# LeRoy Wood Elementary School

## Town of Fairhaven ADA Transition Plan

October 2024

Institute for Human Centered Design

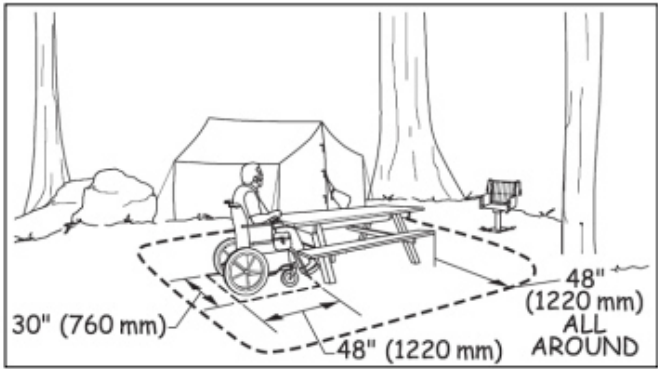
- Recommend providing a stable, firm and slip-resistant surface that is 48" clear on all sides of accessible picnic tables in a manner that is substantially similar to what is shown in the following image:

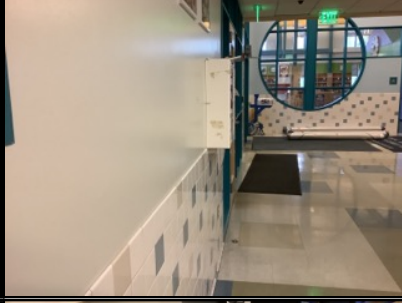
5	Path Leading to Sconicut Neck Road on South/East Side of Site	Ext.	-	Exterior Access Route	Sidewalk		Does not prevent accumulation of water Route not maintained in operable working condition	- -	Repair surface. Ensure the accessible route is maintained in operable working condition.	1	-	-

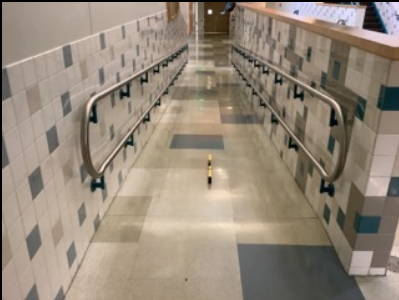
ID	Location	Floor	Room	Element	Type	Photo	Issues	Current Measure	Recommendations	Quantity	Price	Cost Estimation
21	Top of Ramp Leading From Music/ Platform to Gymnasium	1	-	Doors, Doorways, & Gates	Classroom		Maneuvering clearance(s) not provided	15"	Provide an automatic door opener.	1	6000	\$6000
											6000	
22	Single-User Special Education Corridor	1		Doors, Doorways, & Gates	Toilet Room		Maneuvering clearance(s) not provided	-	Relocate the desk to provide 12" of push side maneuvering clearance.	1	Labor	Labor
23	Reading Classroom	1	118	Doors, Doorways, & Gates	Classroom		Maneuvering clearance(s) not provided	11.5"	Relocate the cabinet to provide 18" of pull side maneuvering clearance.	1	Labor	Labor
24	Kindergarten Classroom	1	130	Doors, Doorways, & Gates	Classroom		Maneuvering clearance(s) not provided	-	Relocate shelves to provide 48" clear floor space at the door.	1	Labor	Labor
25	Single-User Toilet Room in Kindergarten Classroom	1	130	Doors, Doorways, & Gates	Classroom		Maneuvering clearance(s) not provided	-	Relocate the storage bins to provide 18" of pull side maneuvering clearance.	1	Labor	Labor

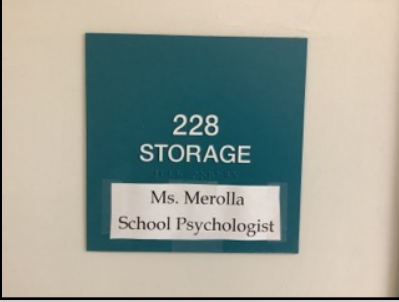
6000	
29	Music/ Platform	1	104	Doors, Doorways, & Gates	Classroom		Maneuvering clearance not provided at recess > 6"	11.5"	Install an automatic door opener or rebuild the doors so that the doors are not recessed greater than 6" deep on the push or the pull side.  (Cost estimate is for an automatic door opener.)	1	6000	\$6000
											6000	
30	Ensemble Room, Practice Room 105 C	1	105 C	Doors, Doorways, & Gates	Classroom		Maneuvering clearance not provided at recess > 6"	11.5	Install an automatic door opener or rebuild the doors so that the doors are not recessed greater than 6" deep on the push or the pull side.  (Cost estimate is for an automatic door opener.)	2	6000	\$12000
											12000

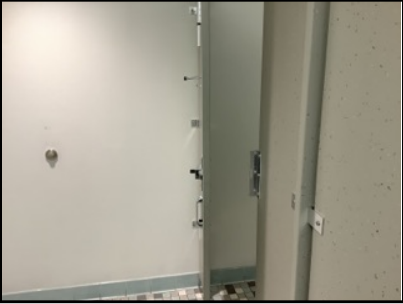
250	
Operable Parts / Reach Range												
45	Next to Main Office/Across From Nurse's Office	1		Operable Parts / Reach Range	Defibrillator		Reach < 15" or > 48"(forward/side approach)	52"	Relocate the defibrillator so that controls are between 15"- 48" above the finished floor.	1	500	\$500
											500
